730-Full2: Drilling the late Quaternary coral record of climate and sea level on subsiding reefs at Sabine Bank and Bougainville Guyot, Vanuatu

730-Full2 - Taylor

Issues requiring follow-up

Sabine Bank

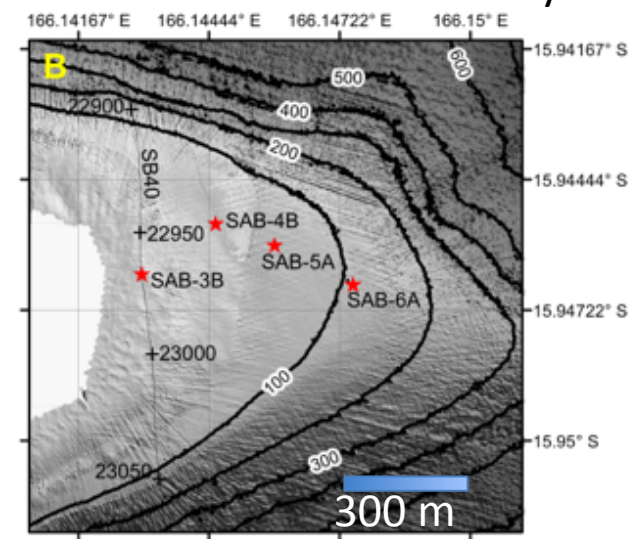
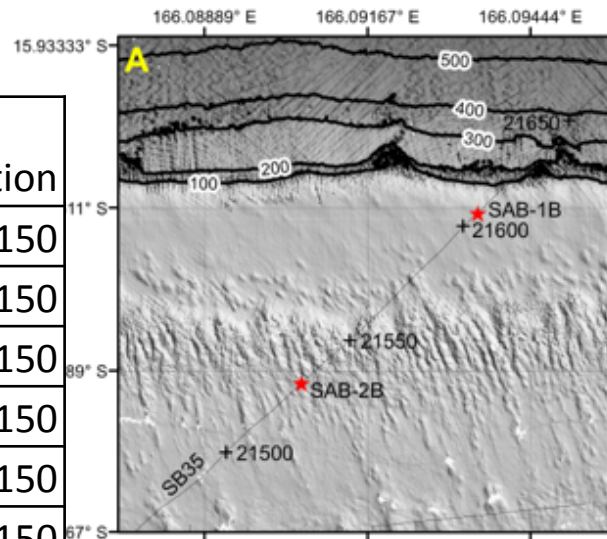
SAB-1B	SAB-2B	SAB-3B	SAB-4B	SAB-5A	SAB-6A
Seismic	SB35 (no xing) 515/21605	SB35 (no xing) 367/21531	SB40 (no xing) 359/22963	150 m away Too steep? 25-30°?	300 m away Too steep?	450 m away Too steep?
Seismic Vel.	Assume 2 km/s					
MCS grid	Numerous lines in region, not necessarily at proposed sites; marginally useful					
3.5 kHz	Chirp & Boomer data provided, but not useful					
Bathymetry	Images (no grids or resolution info)					
Backscatter	Raw data (plot I generated looks good, but not very useful)					
Currents	Tide & current meter data not in SSDB => Still seeking access to current data					
Samples	Site 831 appropriate? Uploaded dredge locations

Bougainville Guyot

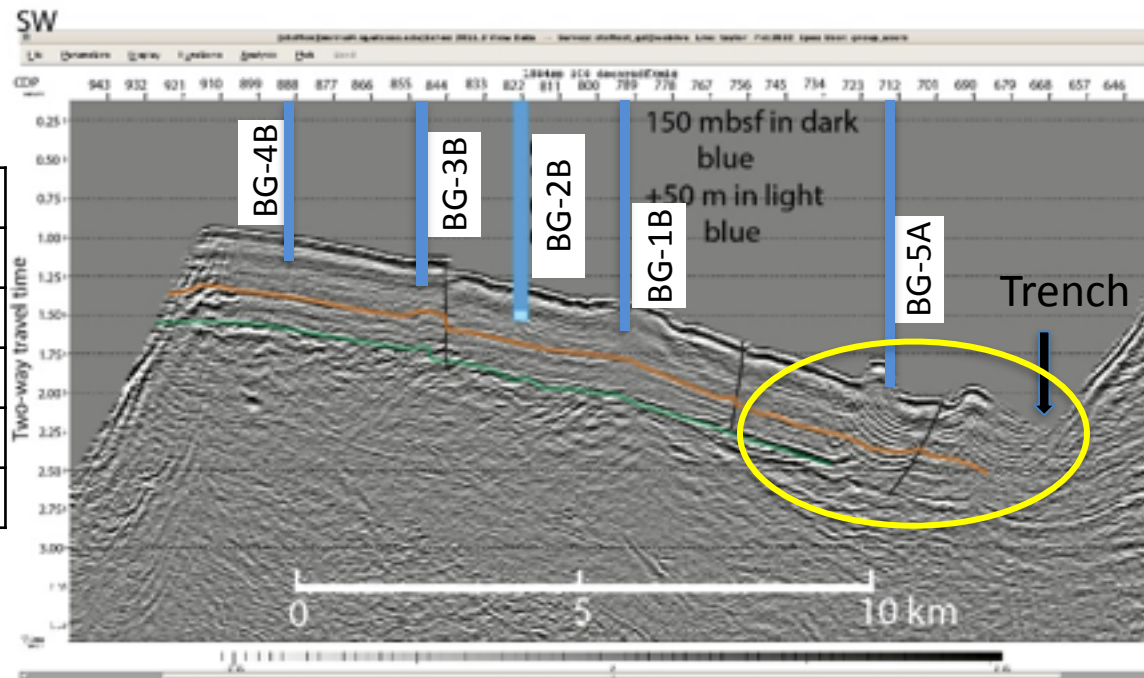
BG-1B	BG-2B	BG-3B	BG-4B	BG-5A
Seismic (acq & proc?)	L5SP84 (no x-ing) CDP 790	L5SP84 (no x-ing) CDP 820	L5SP84 (no x-ing) CDP 851	L5SP84 (no x-ing) 885, 1 km offset	L5SP84 (no x-ing) CDP 718
Seismic Vel.	Assume 2 km/s				
MCS grid	Necessary? No.				
3.5 kHz	Pre-deployment survey?				
Bathymetry	Raw data (old Seabeam nav. not merged) & ASCII table Unable to improve				
Backscatter	None				
Samples	Site 831				
Video/photos	Acquire prior to MoBo deployment?

Site BG-5A => patch reef? (more likely to contain coral heads than lagoonal sites).

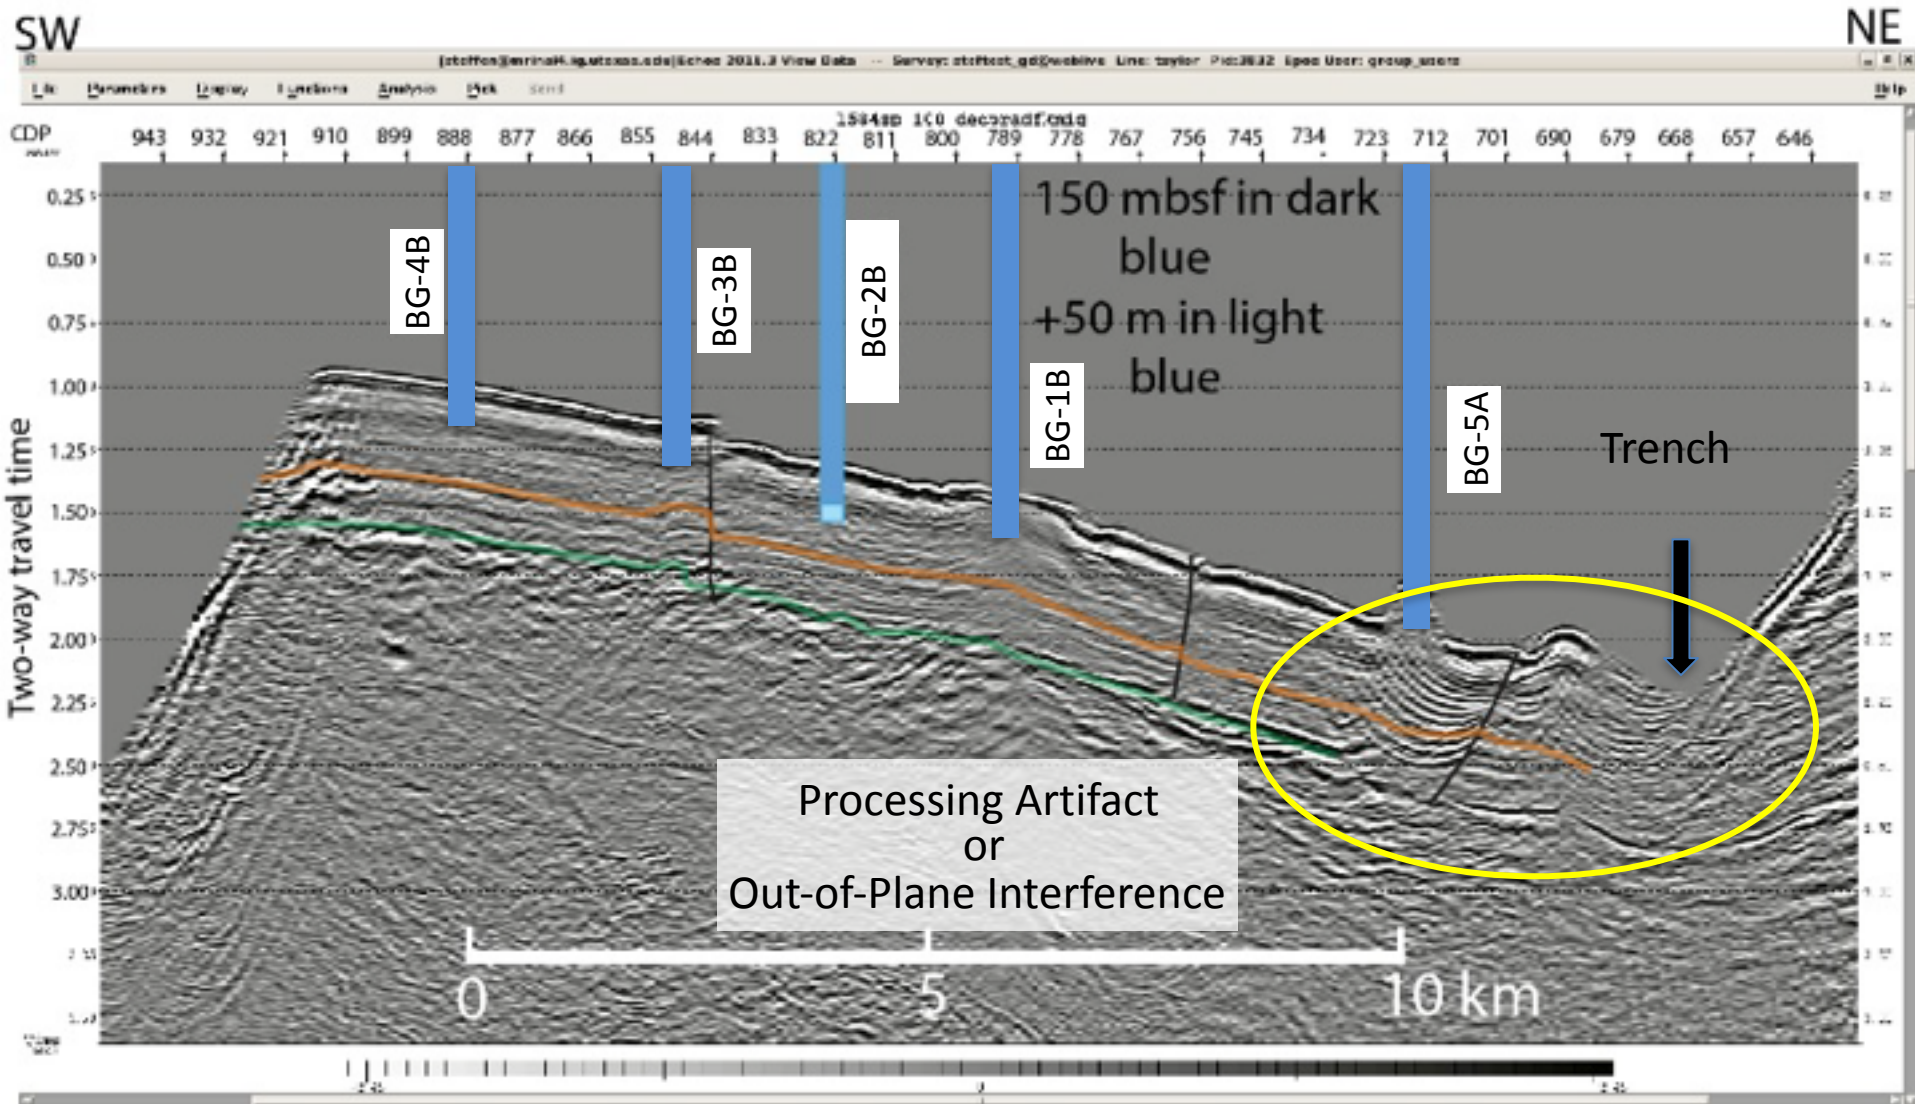
Location of BG-5A

- Processing artifacts
- Risk/Reward of Patch Reef?
